26 July 2024

Planning Act 2008: Norwich to Tilbury Project

South Norfolk Council's Response to the Statutory Consultation, under Section 42 of the Planning Act, between 10 April and 26 July 2024 undertaken by National Grid Electricity Transmission (NGET) for the proposed Norwich to Tilbury (NT) Nationally Significant Infrastructure Project (NSIP).

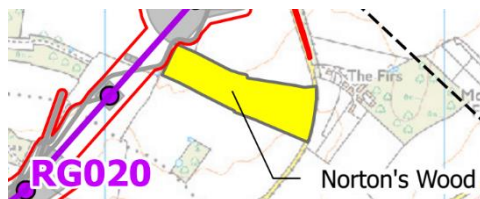
13. [Norton Wood CWS 61](#), adjacent to the draft DCO boundary (see right). In normal planning situations we would request that a suitable buffer¹³ is provided between the temporary access track and the CWS to prevent damage to the CWS and any ancient/veteran trees present (*there is an ancient oak pollard along the southern boundary*). Recent experience with other cable routes has shown that this is necessary to avoid impacts during detailed design i.e. once vehicle tracking paths have been detailed or additional works considered. In the absence of a suitable buffer there is concern that Norton Wood will be indirectly impacted.

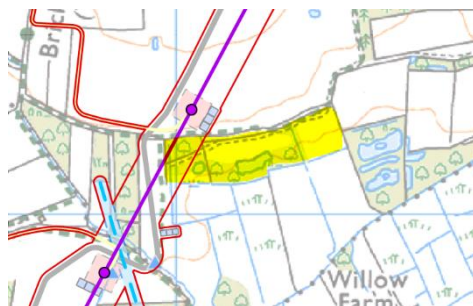
14. The overhead lines pass over [Brick Kiln Lane, Bunwell Hill CWS 2072](#) (see right) which is comprised of a mosaic of grasslands (mainly unimproved marshy grassland), tall-herb fen, and ponds. It is also not clear why, in line with the mitigation hierarchy and the requirements of EN-1, the power lines/pylons have not been sited to avoid impacts. There is potential for direct loss of vegetation to ensure minimum clearance (meters) between vegetation and the power lines, but the extent of loss is not clear. Targeted NVC surveys within the draft order limits at Brick Kiln Plantation (and the wider area to include the woodland to the west), will need to be undertaken at this site and the potential impacts clearly identified as part of the ES¹⁴. In normal planning situations this would not be acceptable as it is contrary to the NPPF and Policy 3 of the GNLP. As noted above all CWS should be excluded from the red line and appropriately buffered.

Figure 1

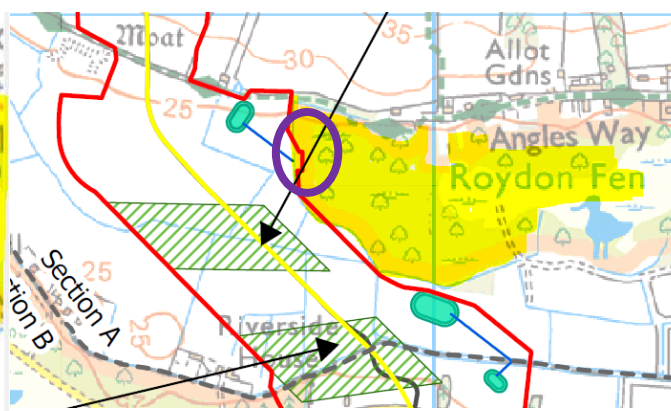
15. **Royden Fen CWS** has been incorrectly identified as being located within Suffolk and its designation has also been missed out from several sections including Annex B and Figure 8 of the reptile report.
16. [Roydon Fen CWS](#) (and LNR) is located within the red line boundary for both the overhead power line and Waveney Valley Alternative options (see below). The former with regards to overhead line mitigation work area (wood pile lines) (see Figure 1) and

the latter with regards to temporary attenuation drainage existing into the ditch which forms the boundary of the CWS (see Figure 2). An NVC survey (survey site 12) is planned in 2024 for the parts of the CWS impacted (see Figure A.8.1.3).

17. It is not clear what the overhead line mitigation works involve and it is requested that the temporary attenuation drainage is re-designed to avoid the CWS, and a suitable buffer (works exclusion zone) provided around the CWS. The extent of hydrological impacts on the ecological interest of the CWS is of serious concern and must be clearly considered, for each CWS, within the ES.
18. The inclusion of the CWS within the red line is contrary to EN-1 Overarching National Policy Statement for Energy which states that projects should follow the mitigation hierarchy and avoid harm. The CWS should be avoided in its entirety and a suitable buffer provided between the works area and CWS boundary.

Image 4.2 – Expected Overhead Line vegetation clearance requirements

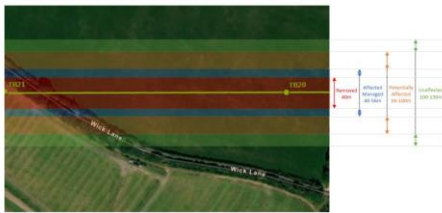
31. With regards to assisting with understanding - an illustration showing expected vegetation clearance requirements of the WVA should be included for clarity within the

ES to supplement those provided for overhead²⁷ and haul road²⁸ vegetation clearance. The extent of vegetation loss needs to be clearly identified.

Figure 3 2024/1336 BNG proposal for the extension

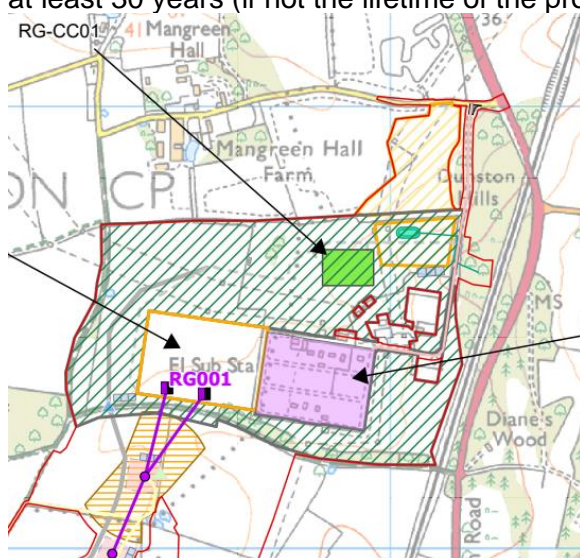
54. The Norwich main substation extension and Environmental Area proposed around Norwich Main Substation⁴⁴, ⁴⁵ also forms part of a current planning application lodged with South Norfolk District Council - application reference 2024/1336 ⁴⁶ (validated 01/05/2024). If the planning application is granted it will affect the provision of BNG for the DCO ⁴⁷.
